Access Compliance Report

Public Rights-of-Way

Intersection ID: 53391	Main Street: EBBETS_RD	Cross Street: VAWTER_DR	Location: SE
ADA ID: 1DA33FF8568A	Ramp Type: Perp	Initial Pass/Fail: Fail	Overall Compliance: No
		Severity Score: 12.5

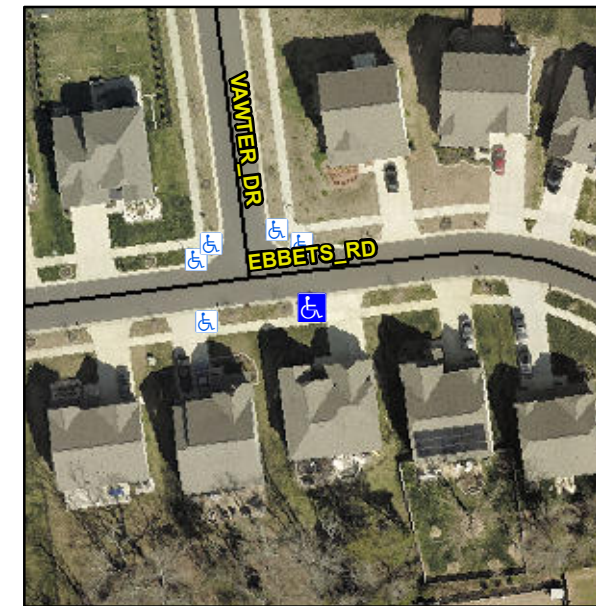
R304.5.3

Compliance	Description	Data	Compliance	Description	Data
N/A	Ramp Length (in)	96.0	Yes	Ramp Slope (%)	5.1
Yes	Ramp Width (in)	48.0	No	Ramp XSlope (%)	6.0
N/A	Flare Type LT	N/A	N/A	Flare Type RT	N/A
N/A	Flare Slope LT (%)	N/A	N/A	Flare Slope RT (%)	N/A
N/A	Flare Traversable LT?	N/A	N/A	Flare Traversable RT?	N/A
N/A	Landing Length (in)	N/A	N/A	DWS Provided?	N/A
N/A	Landing Width (in)	N/A	N/A	DWS Contrast?	N/A
N/A	Landing Slope (%)	N/A	N/A	DWS Length (in)	N/A
N/A	Landing X Slope (%)	N/A	N/A	DWS Full Width?	N/A
N/A	Landing Curb? (Y/N)	N/A	N/A	DWS Offset (in)	N/A
N/A	Shared Landing?	N/A			
N/A	Gutter Ponding?	N/A	N/A	Gutter Slope (%)	N/A
N/A	Gutter Lip Ht (in)	N/A	N/A	Gutter X Slope (%)	N/A
N/A	Painted X Walk1?	No	N/A	Painted X Walk2?	N/A
	X Walk 1 Direction	To N		X Walk 2 Direction	N/A
N/A	X Walk 1 Width (in)	N/A	N/A	X Walk 2 Width (in)	N/A
	X Walk 1 Slope (%)	2.1		X Walk 2 Slope (%)	N/A
	X Walk 1 X Slope (%)	3.7		X Walk 2 X Slope (%)	N/A

Remove & Replace Entire Ramp.
